COA-0032-2019

1016 W CABARRUS STREET

Nature of Project:
Demolish shed; remove rear addition,
front porch, vinyl siding; construct
rear addition, front porch, railing and
stairs; remove and replace front
walkway and driveway; install storm
windows, gutters, downspouts;
replace roofing; changes to windows
and doors; repair and paint existing
siding

APPLICATION FOR A CERTIFICATE OF APPROPRIATENESS – STAFF REPORT

BUILT MASS DIAGRAM

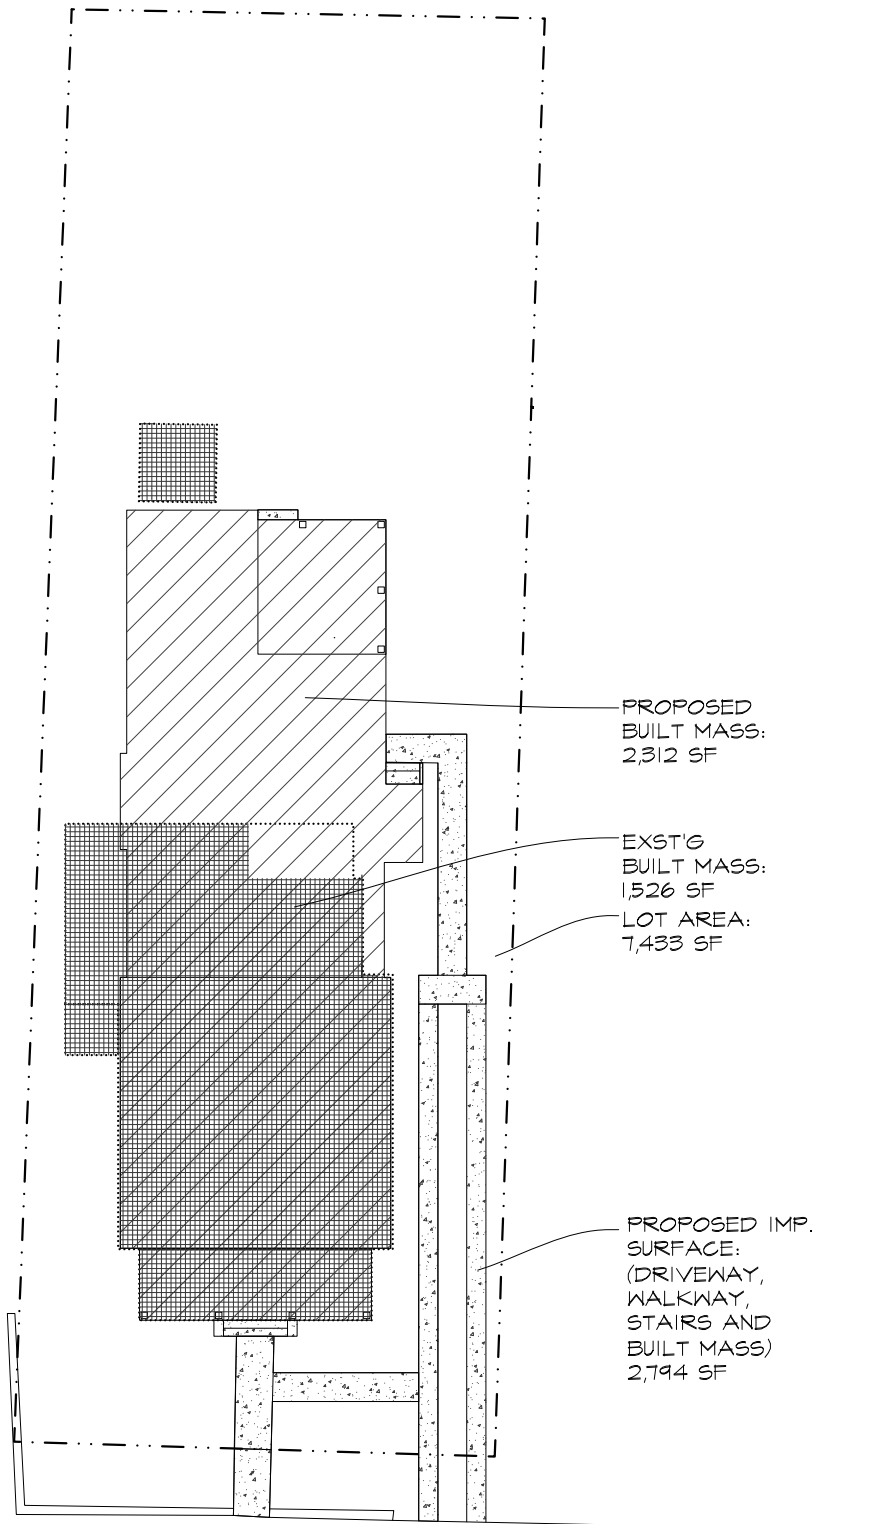
- 5* **Built mass to open space analysis:** According to the applicant, the lot is 7,433 SF. The existing built mass totals 1,526 SF, which apparently includes the front porch and rear addition that is proposed to be removed. The proportion of built mass to open space is now 20.5%. The proposed built mass totals 2,329 SF, which apparently includes the front porch and new addition. The proportion of built mass to open space is proposed to be 31.3%.

- 6* According to *Guideline 3.2.11* calculations for built mass are intended to be based on the *original* built mass of the house not including subsequent additions outside the period of significance: “It is not appropriate to construct an addition that significantly changes the proportion of *original* built mass to open space on the individual site.”

- 7* **Built area to open space analysis:** According to the applicant, the lot is 7,433 SF. The existing built area totals 1,725 SF, which includes the house, porch, shed and walkway; the driveway does not appear to have been included. The proportion of built area to open space is now 23.2%. The proposed built area totals 2,794 SF, which includes the house, porch, sidewalk, and driveway. The proportion of built area to open space is proposed to be 37.6%.

- 8* According to *Guideline 1.3.8* calculations for built area are intended to be based on the *original* built area of the house not including subsequent additions outside the period of significance: “In the residential historic districts, it is not appropriate to alter the residential character of the district by significantly reducing the proportion of the *original* built area to open space on a given site through new construction, additions, or surface paving.”

- 9* The application states; “The proposed built area and mass are consistent with the neighbors”, and “Other addresses along W Cabarrus range from 21% to 39% lot coverage.” Comparisons are included with 1012 W Cabarrus Street which has a recent addition (COA #125-17-CA) that has resulted in built mass to open space of 41% and built area to open space of 43%.

PROPOSED PLOT PLAN

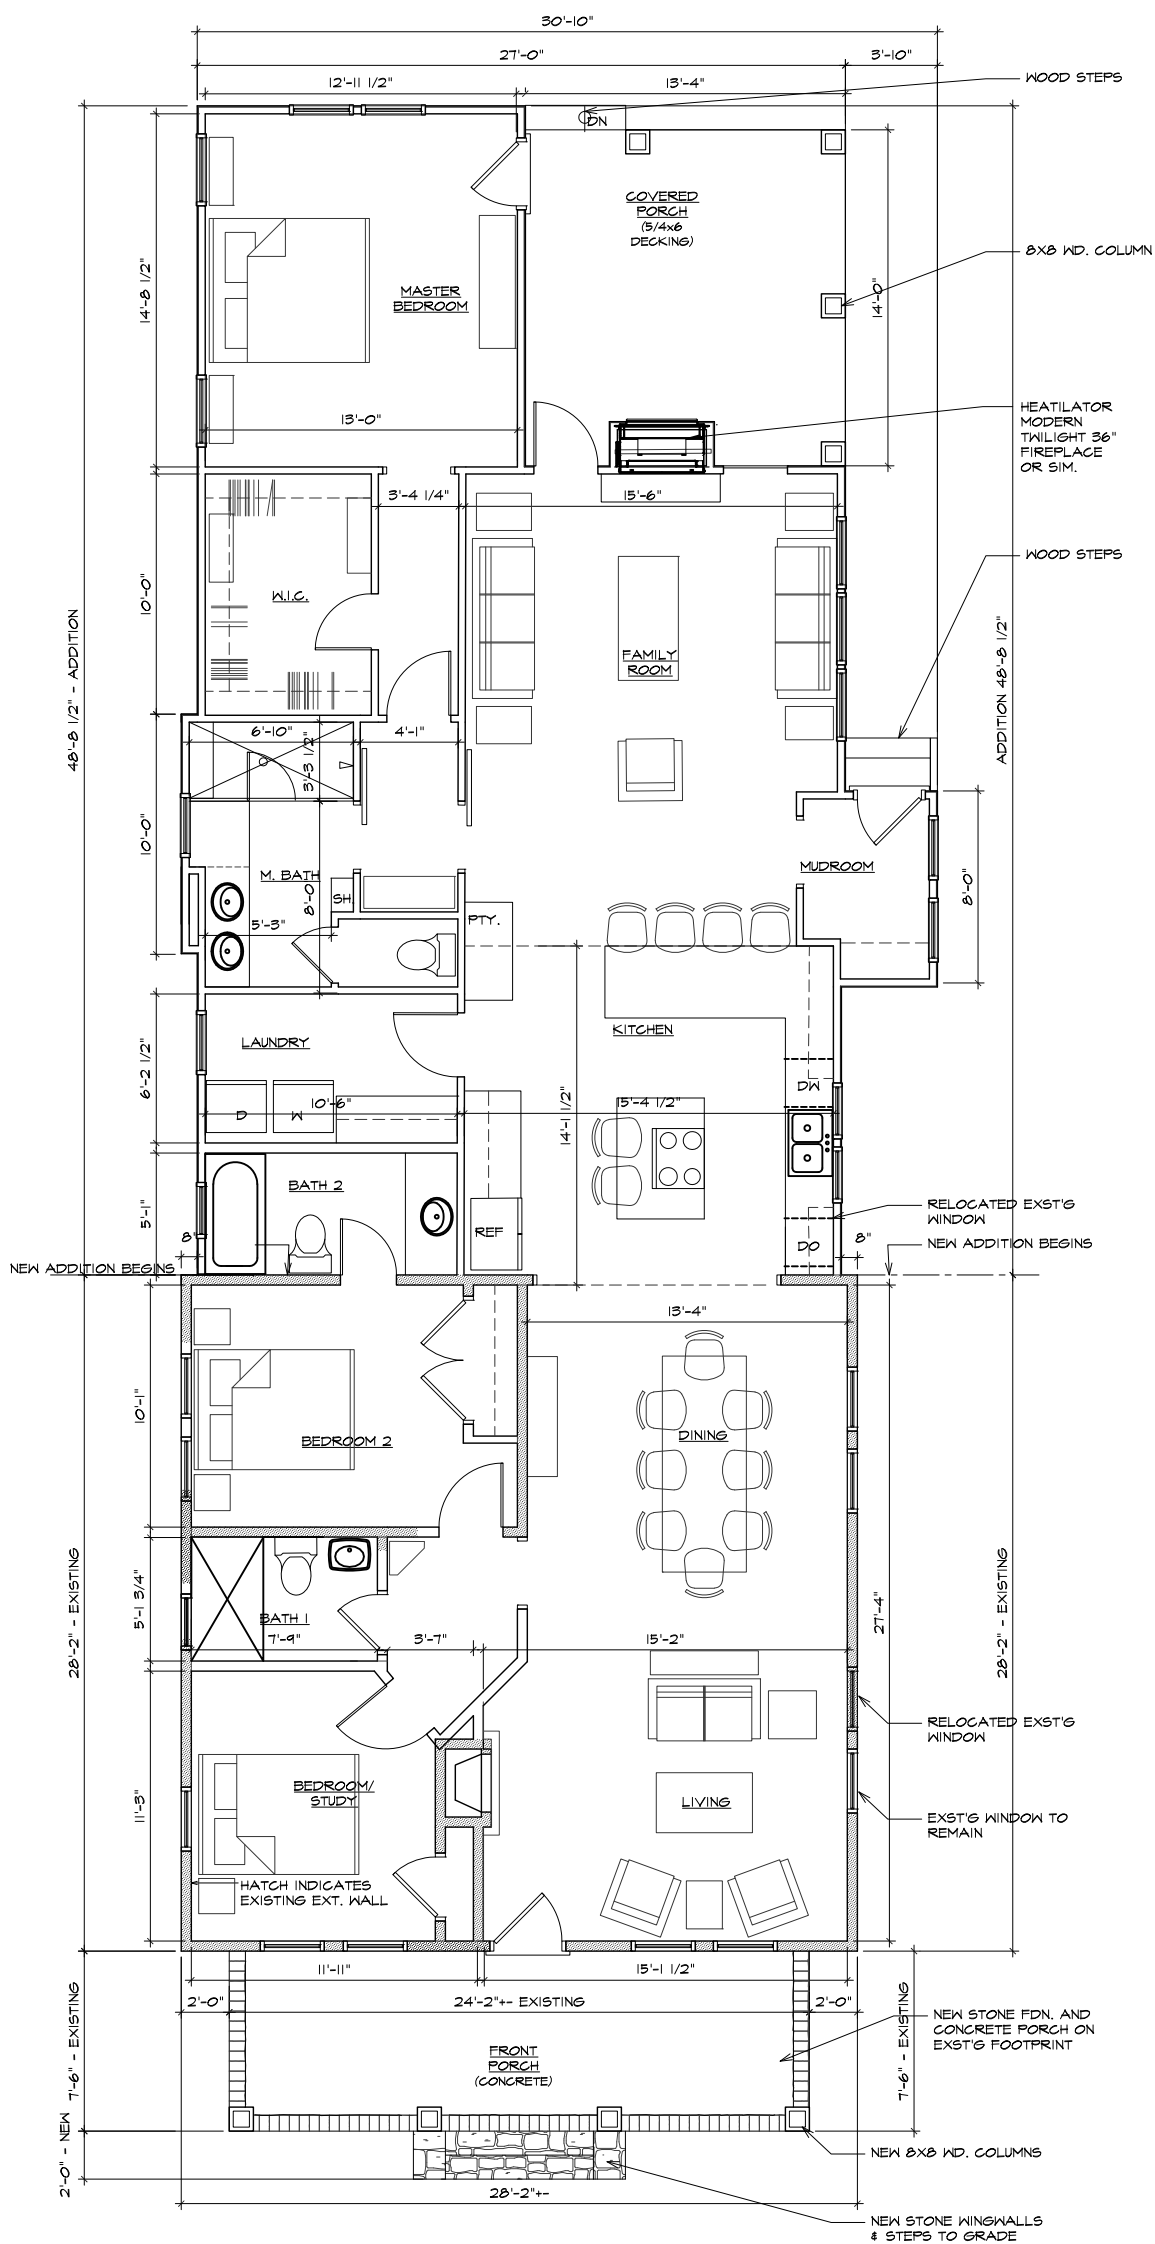
- 3* The application states there are no trees over 8” in diameter on the property. The proposed plot plan shows two trees on the neighboring property to the rear along with tree protection fencing just outside of what appears to be the drip line.

PROPOSED RIGHT ELEVATION

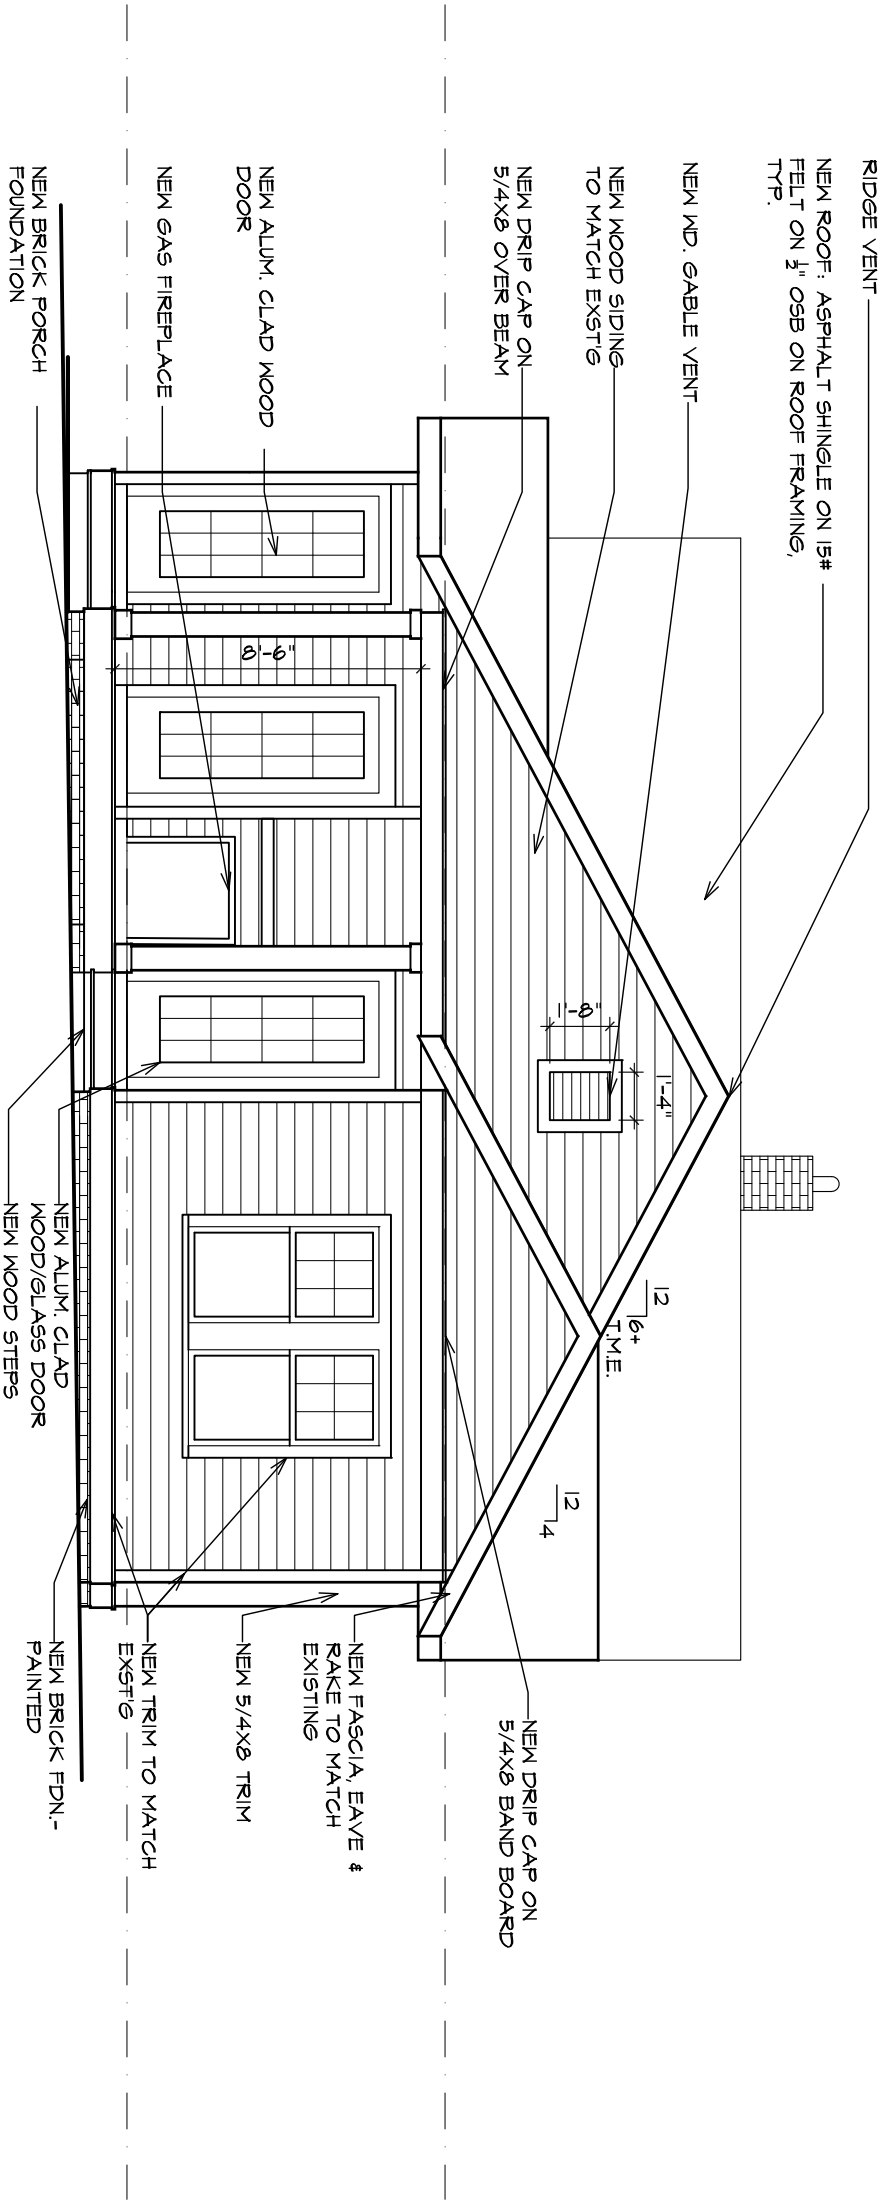
18* A gas fireplace is proposed on the south wall of the rear porch. It appears to be clad in the same siding as the rest of the addition. There are no detailed drawings of the fireplace and its side profile does not appear in the right/east elevation drawing. It is in an inconspicuous location.

PROPOSED REAR ELEVATION

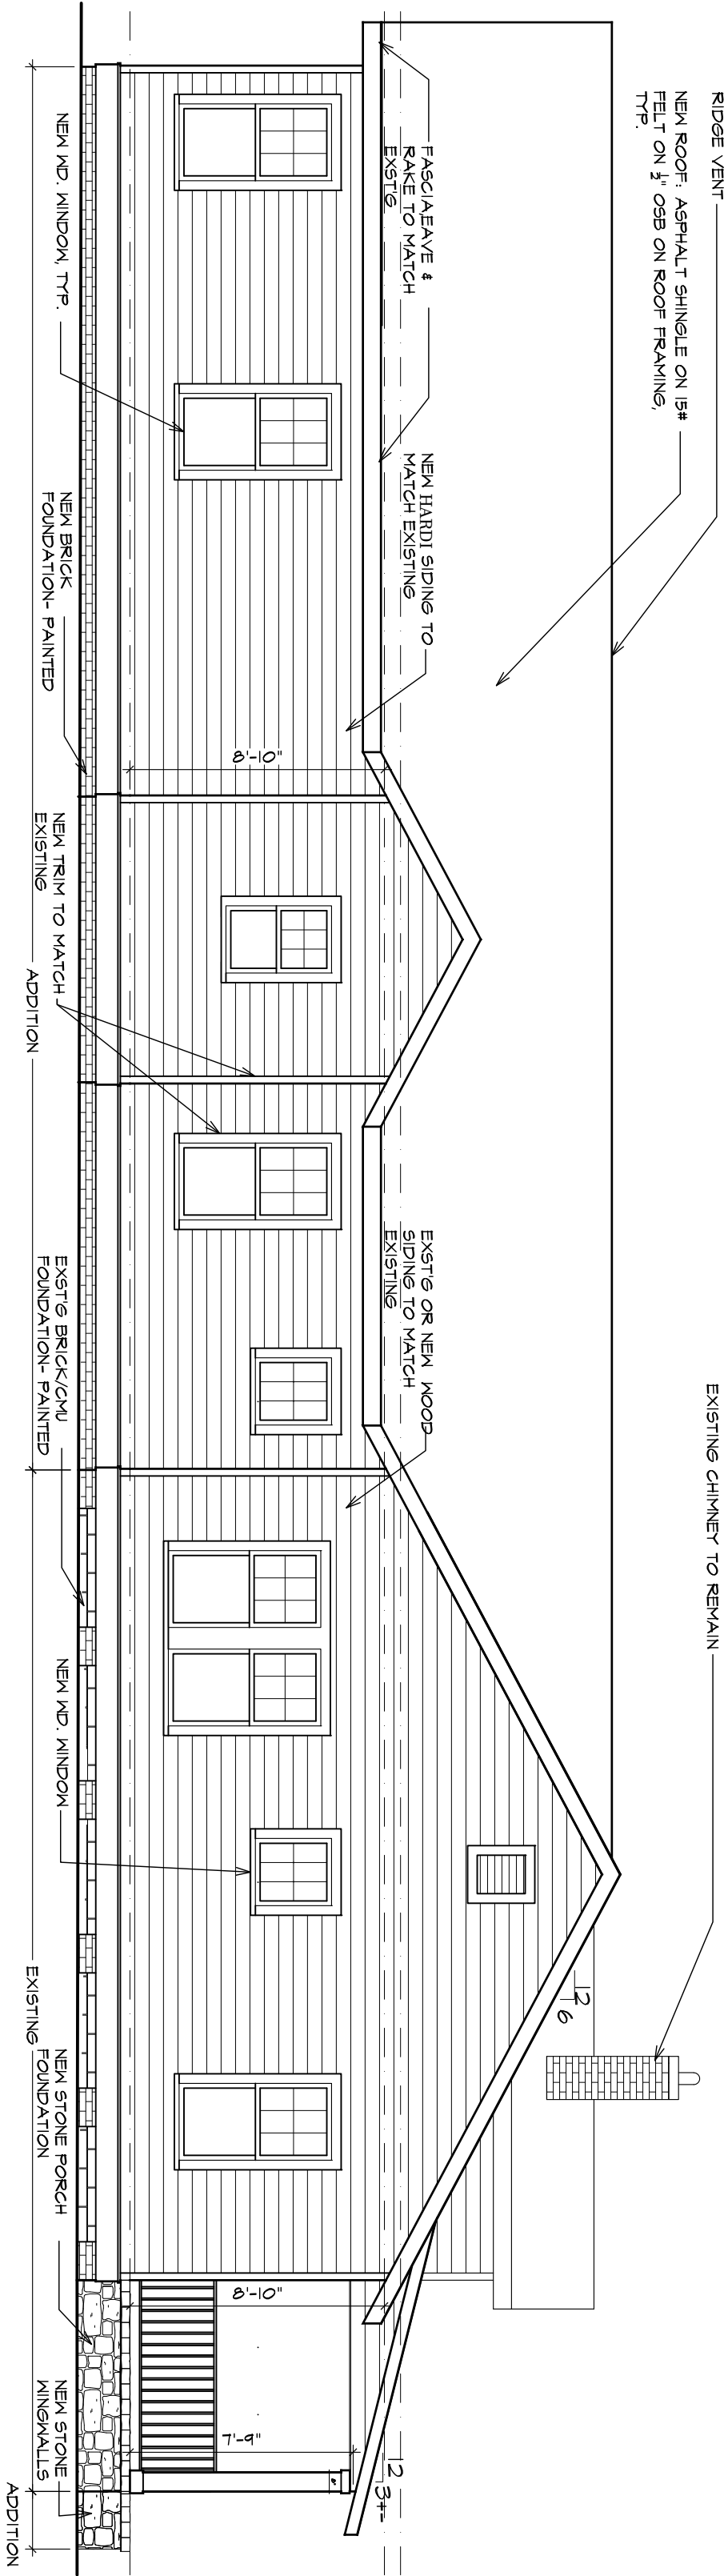
- 11* The rear elevation includes an additional non-functional gable over the enclosed portion of the rear. It also includes a square gable vent that appears to match the one on the right/east side.

METAL RAILING

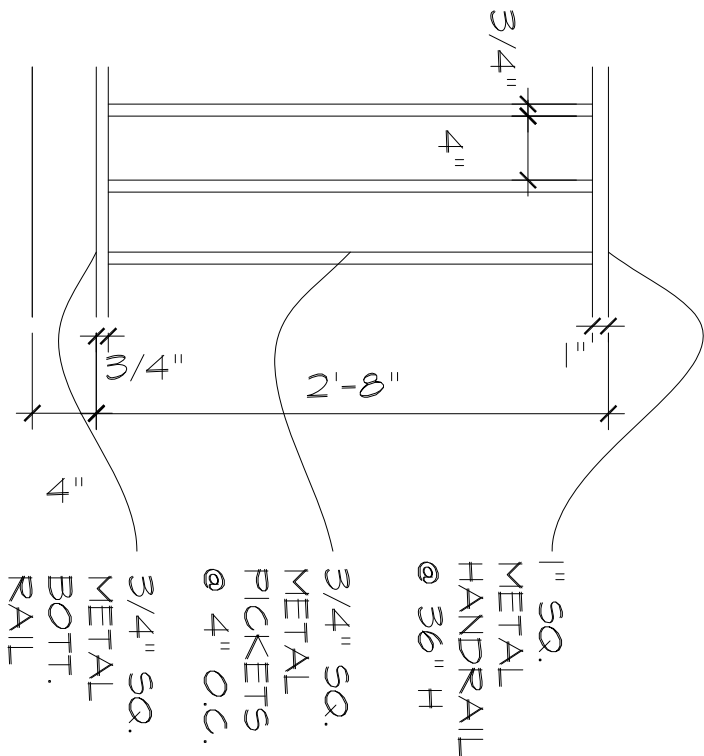
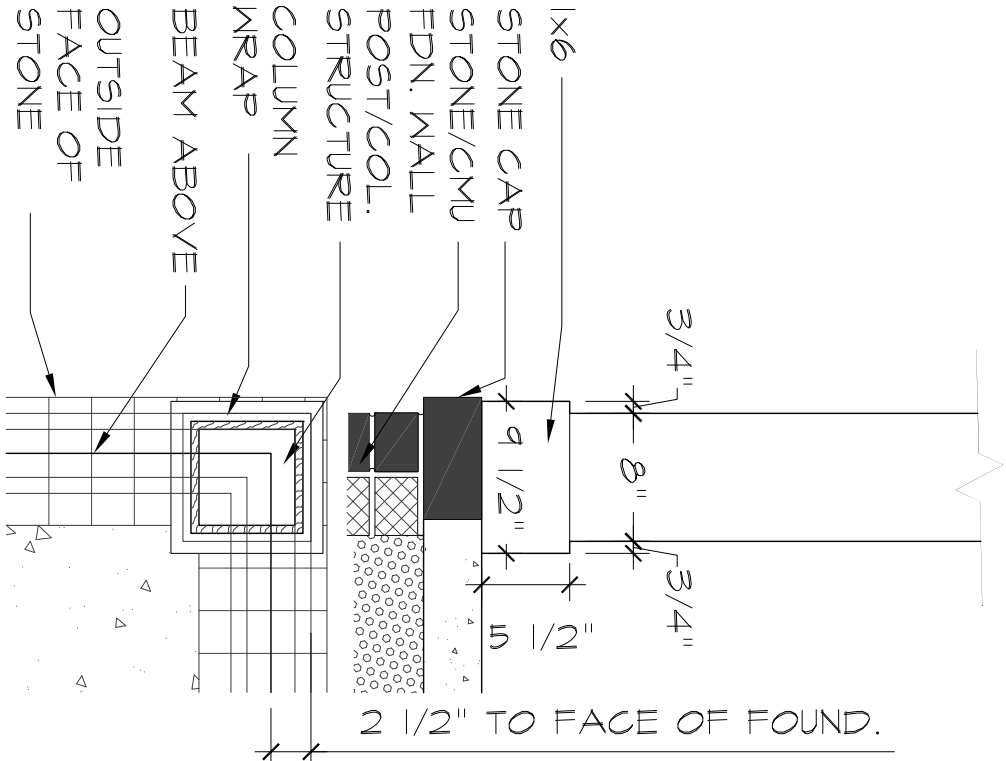
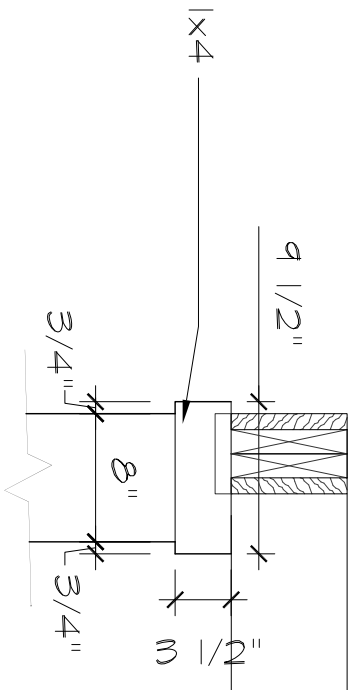
16* The application proposes installing a metal railing around the front porch, including a double-hinged gate at the top of the stairs. Gates on front porches are atypical in the historic district. A photo of a gate enclosing the front porch is shown at 1012 W Cabarrus Street; however, this gate was not approved with a COA. A detailed drawing of the proposed metal railing was provided.
